HGY/2023/3404: Channing School, Highgate Hill

Appendices

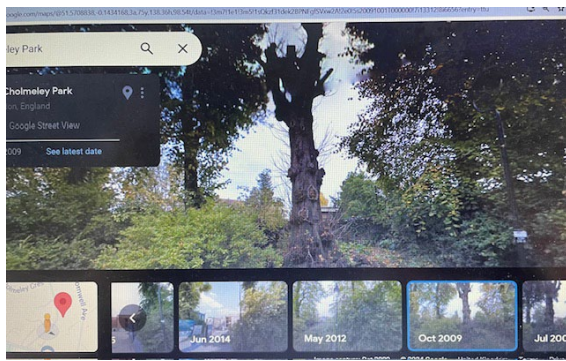
From Elevation D, it would appear that the decorative ridgeline and the cupola, which add to the charm of the building, will be lost.

The changes to the roof and roof line of the original building will impact negatively on Cholmeley Park.

The decorative ridgeline and the cupola will go, to be replaced by a long unadorned ridge.

StreetView Cholmeley Park 2022

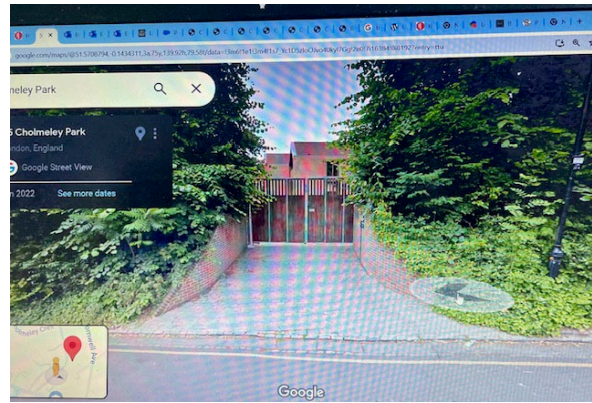
The new build to the North East would further urbanise the view from Cholmeley Park. There used to be a bank of mature limes, totally screening the school site. This was broken in 2012 when a tree was felled to break open the wall and insert a gate.

The further building, visible from the public road would negatively impact on the Conservation Area. The applicant should present verifiable CGI images of the view of the proposed building from Cholmeley Park, between 55 and 57 Cholmeley Park.
